CITY OF ELBERTON**SPLASH PAD FACILITY**

Engineer's Project No. 448-10A

ADDENDUM NO. 2

January 10, 2025

DESIGNED BY LCH	SCALE AS SHOWN	DATE SEP. 30, 2024	SHEET 448-10A3-04
DRAWN BY JCP	APPROVED BY CDQ	PEOPLES & QUIGLEY, INC. CONSULTING ENGINEERS 6059 BOYLSTON DRIVE, NE SANDY SPRINGS, GEORGIA 30328 TELEPHONE (404) 255-2650	13
CHECKED BY KAB

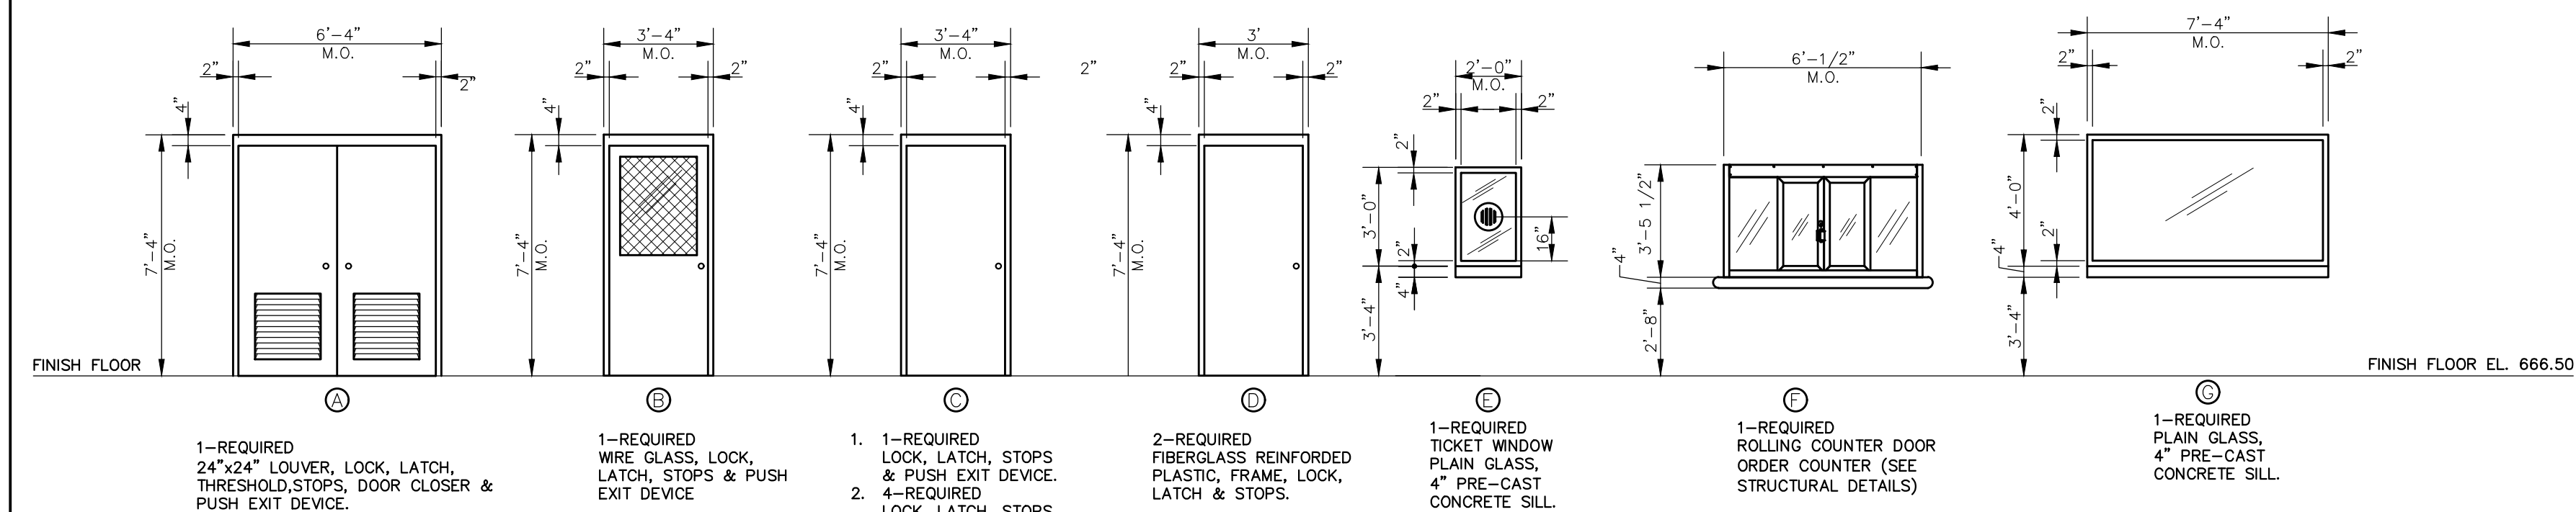
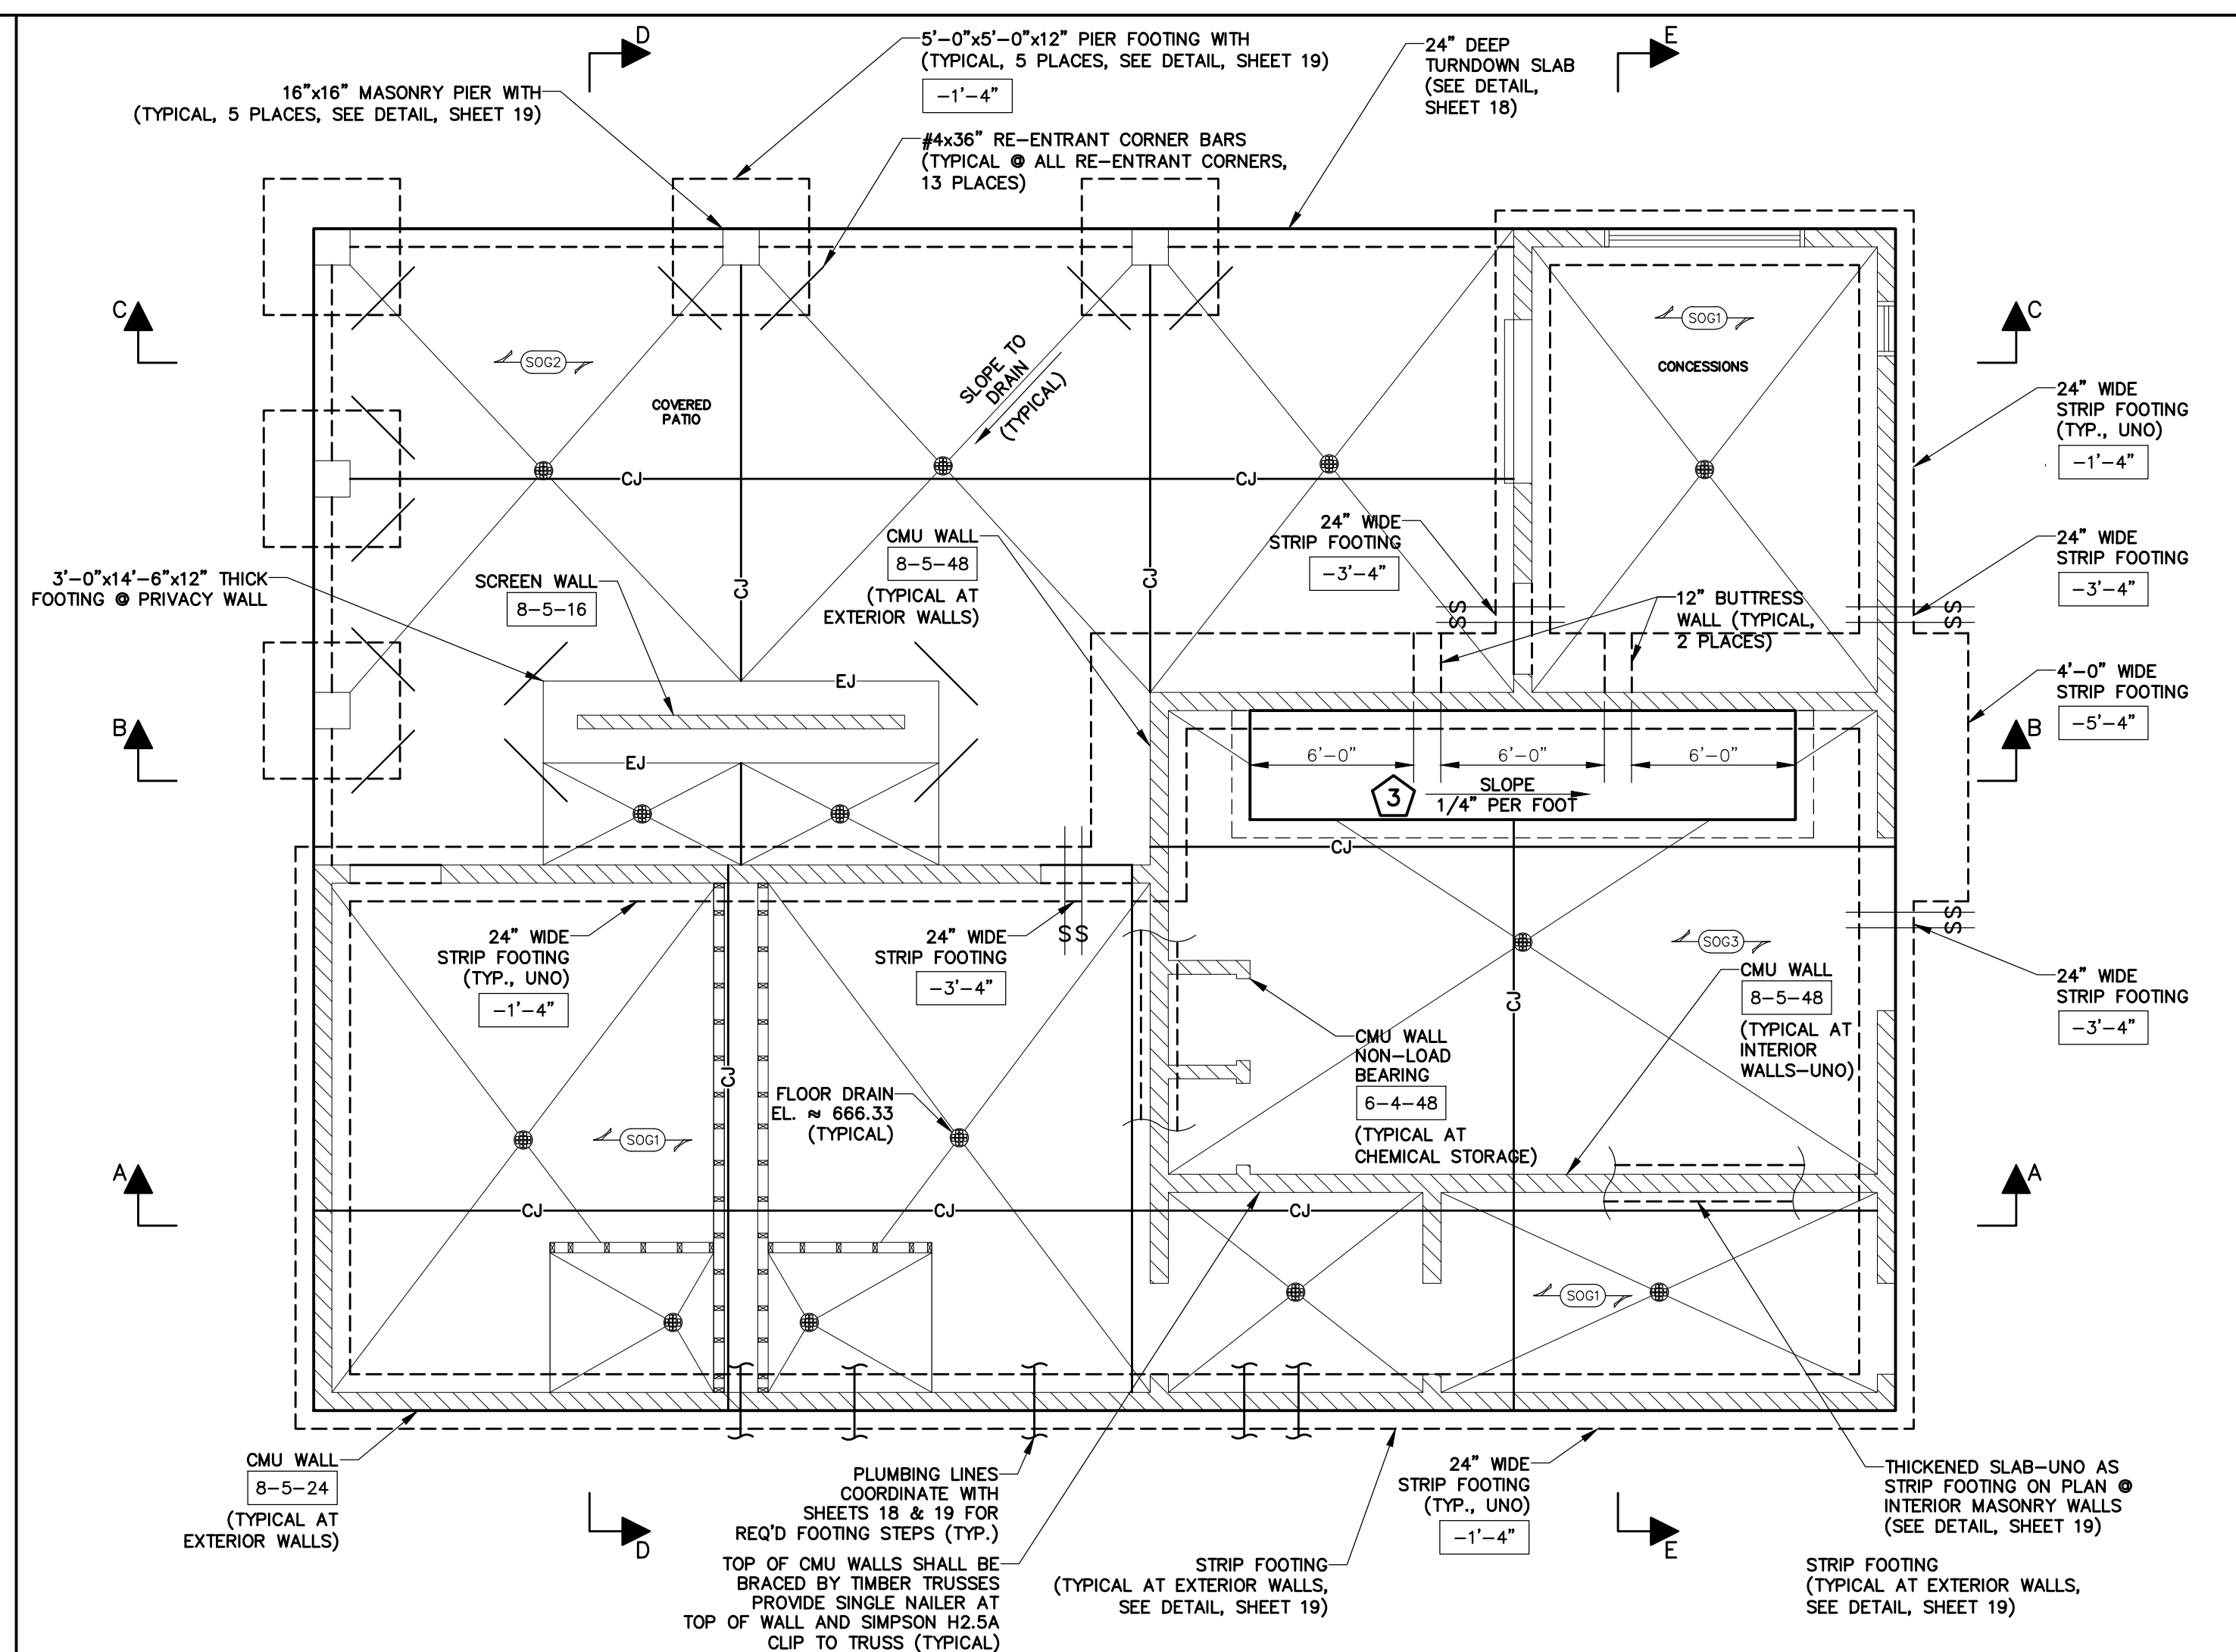
3. On page 13, the window details for Window F and Window G show two of each required, but the floor plan only shows one of each. Where is the second window located?

30. Page 13 notes Door B shows 3 doors required and the drawing only shows 1 door.

31. Page 13 notes Door C shows 8 doors required and the drawing only has 5 doors.

32. Page 13 Door hardware need clarification on the type of hardware to be provided for each door.

Quantities are 1 each per detail on sheet 13.

See updated drawings on sheet 13.

See updated drawings on sheet 13.

Type 1 should be in/out of the electrical room, and type 2 should be for the maintenance closet and bathrooms.

BUILDING ROOF PLAN & DETAILS

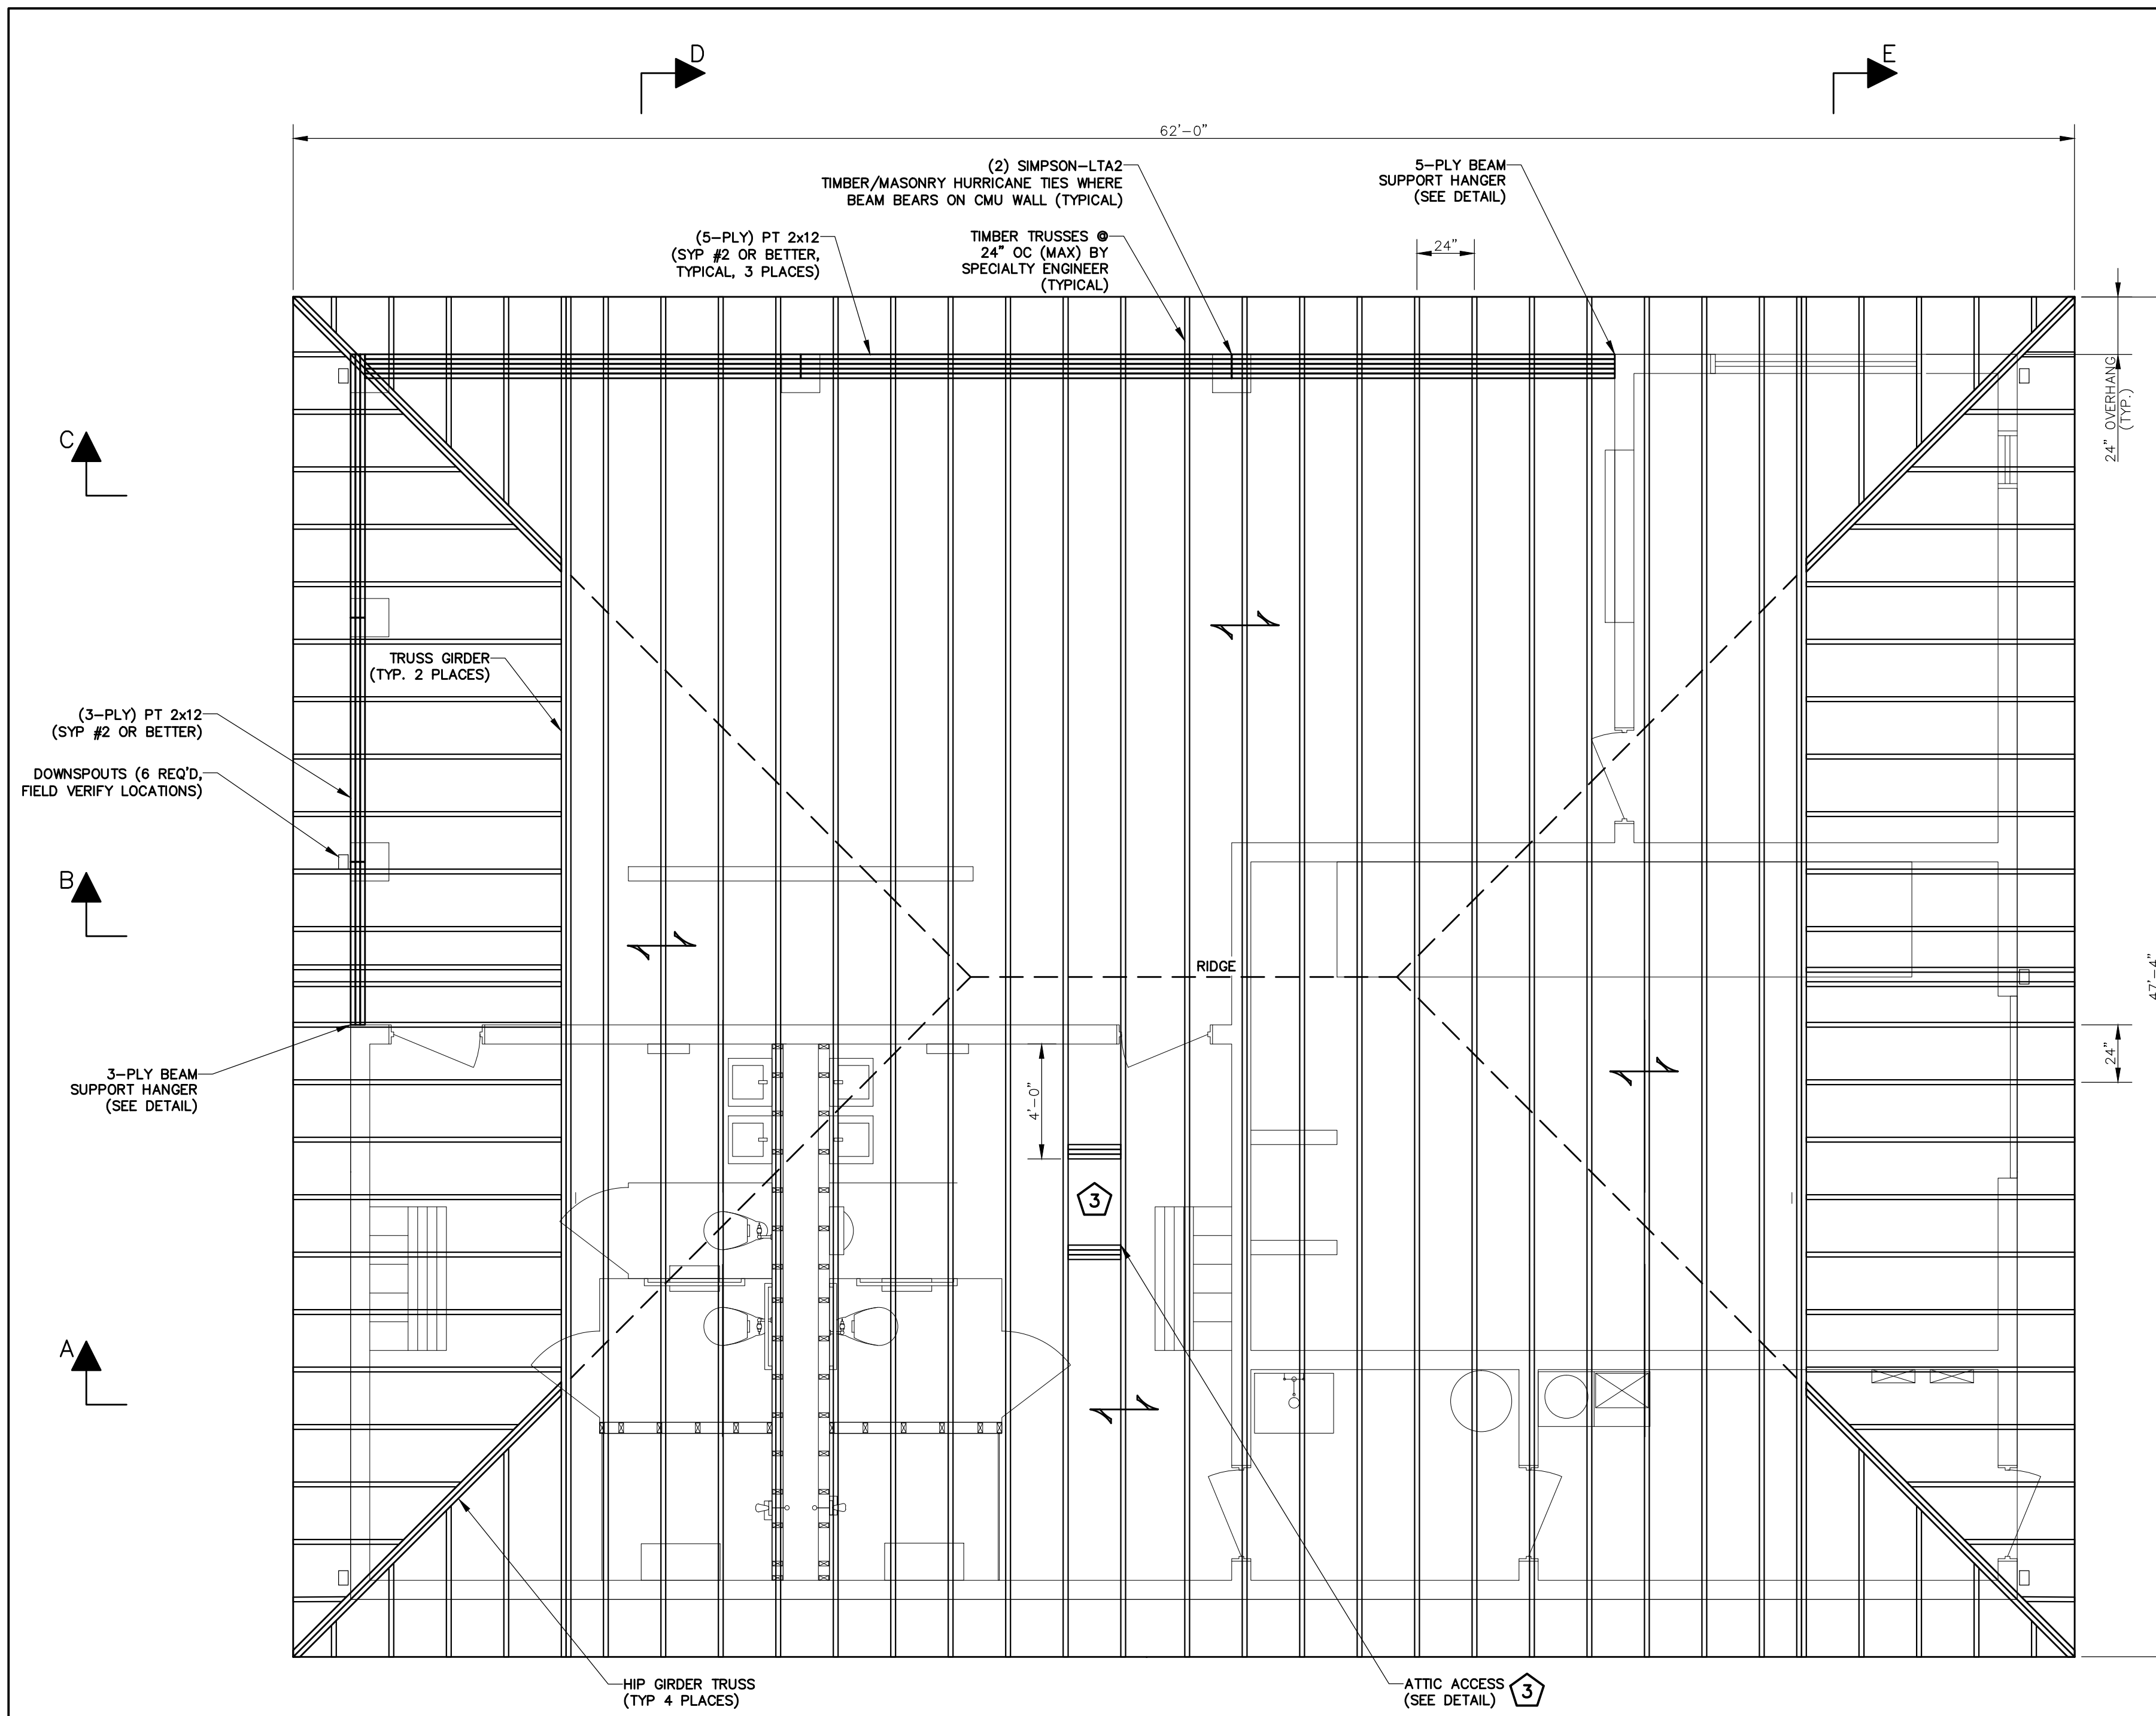
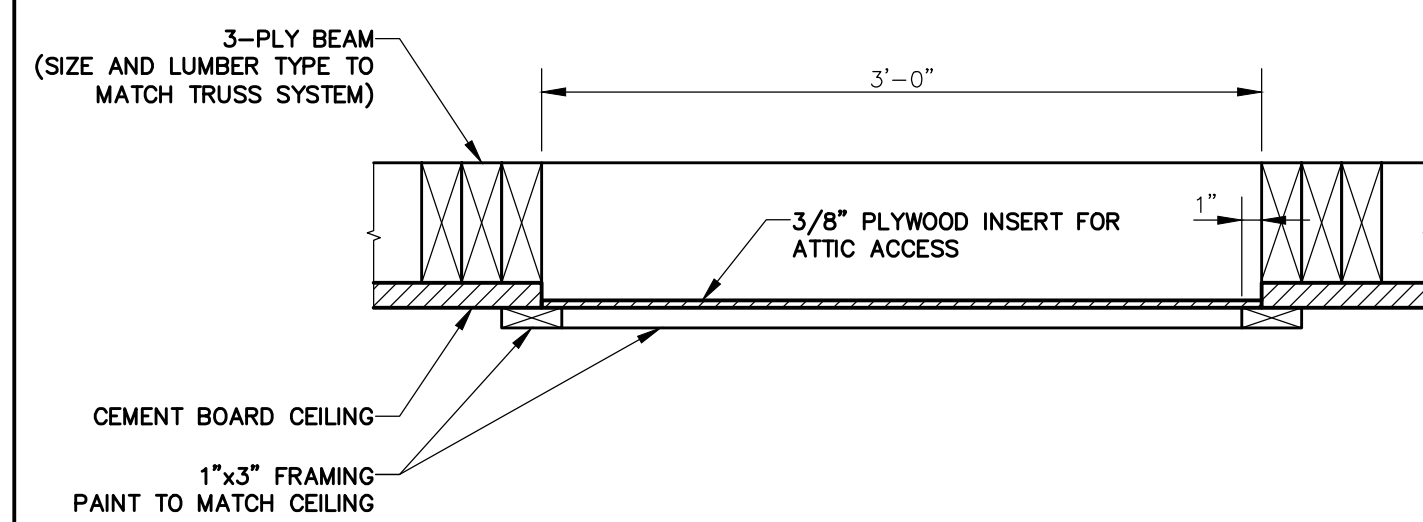
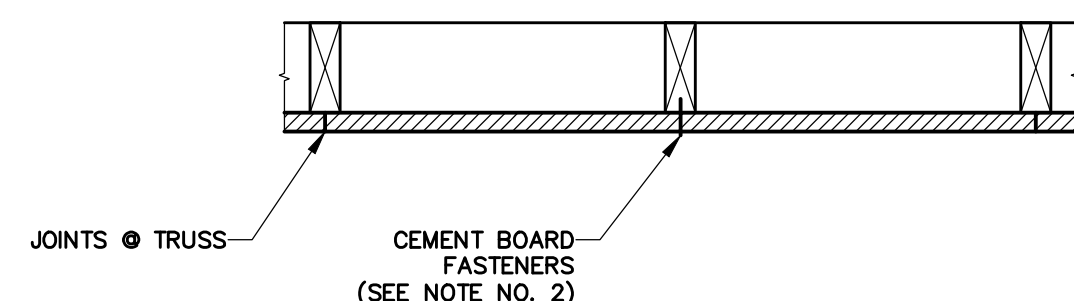
4. Will there be access to the attic space? It is not shown on the drawings.

5. There is no ceiling detail provided. Will one be issued?

See drawings and details on sheet 15.

See drawings and details on sheet 15.
